1822 Bank Street

URBAN DESIGN BRIEF - R6

February 25, 2026

RESPONSE TO PRIOR URBAN DESIGN COMMENTS

VIEW FROM ABOVE NORTHWEST SHOWING 45 DEGREE ANGULAR PLANE

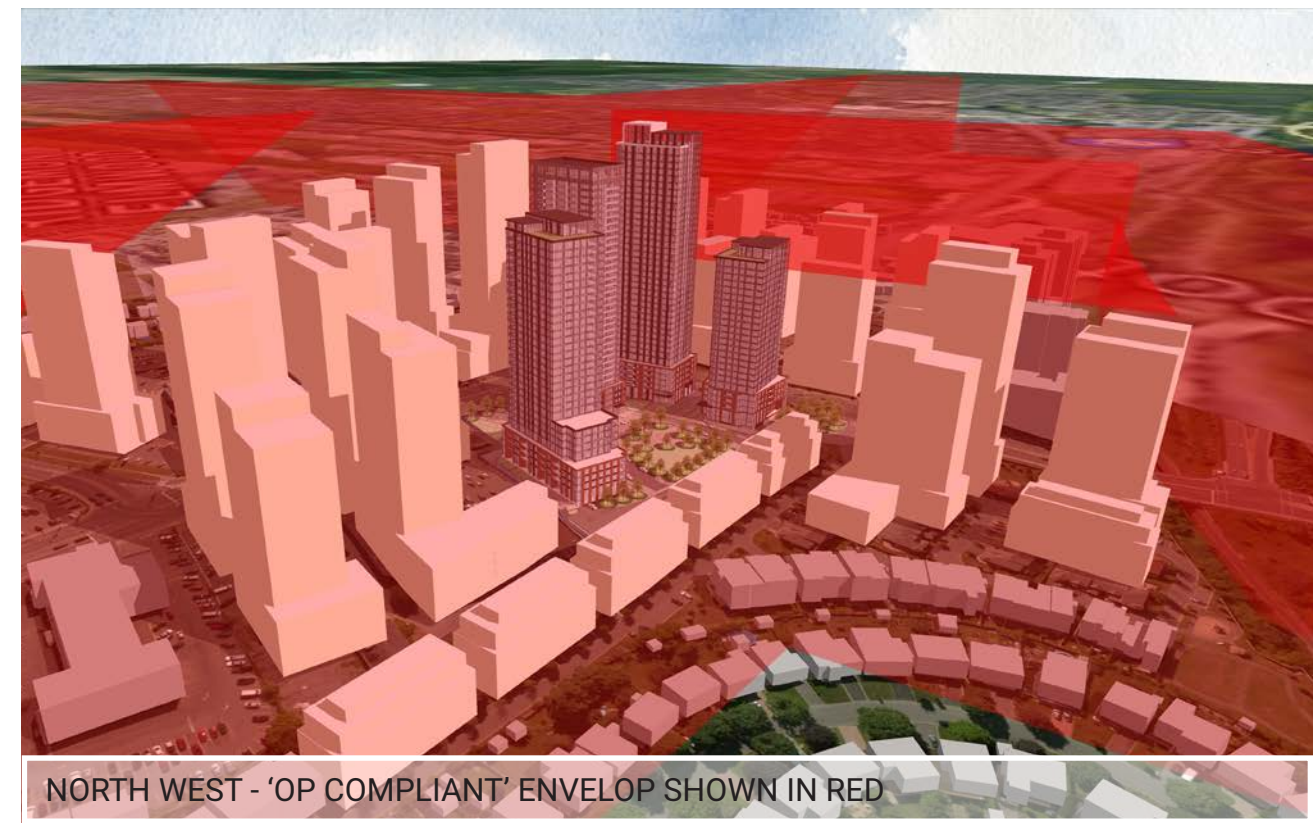
17. Towers 1 and 4 protrude significantly above the 45-degree angular planes as shown on page 20 of the submitted Design Package.

ii. Tower 4 – The height should be reduced. It is interesting to note that if Tower 4 is a 16-storey building, permitted by the Secondary Plan, it will not protrude above the angular plane.

28. Slide 20 of the Design Package demonstrates the buildings projecting above the angular plane. While the angular plane is not meant to be a rigid determination of heights, it does inform the general appropriateness of building heights. In this case, it seems to me that Building 4 should be reduced by several storeys. In addition to improving the building height transition, this would add more variation to the building heights.

Applicant: Please refer to the angular plane diagrams included in the UDRP submission set. We feel that the proximity to the transit station and future development potential under the OP justifies some elements of the development breaking the 45 degree angular planes. The trade-off the proposed development offers is providing the majority of the western edge as greenspace. This minimizes the number of the existing townhomes impacted by overlook / shadowing.

Applicant: We acknowledge that towers 1 and 4 protude through the angular plane. However we feel that this massing response is reason given the significant adjacent open space gained by locating the park at the west side of the property closest to adjacent low-rise. The park location serves to balance the impacts of the taller building forms. Additional, building 1 is the closest of the buildings to the new transit station, and therefore an appropriate location for a taller / higher density form. To help mitigate the impacts on, and improve transition from, the lowrise neighbour to the west, we have reduced Building 4 by 2 storeys to 32 storeys and increased Building 3 to 36 storeys.
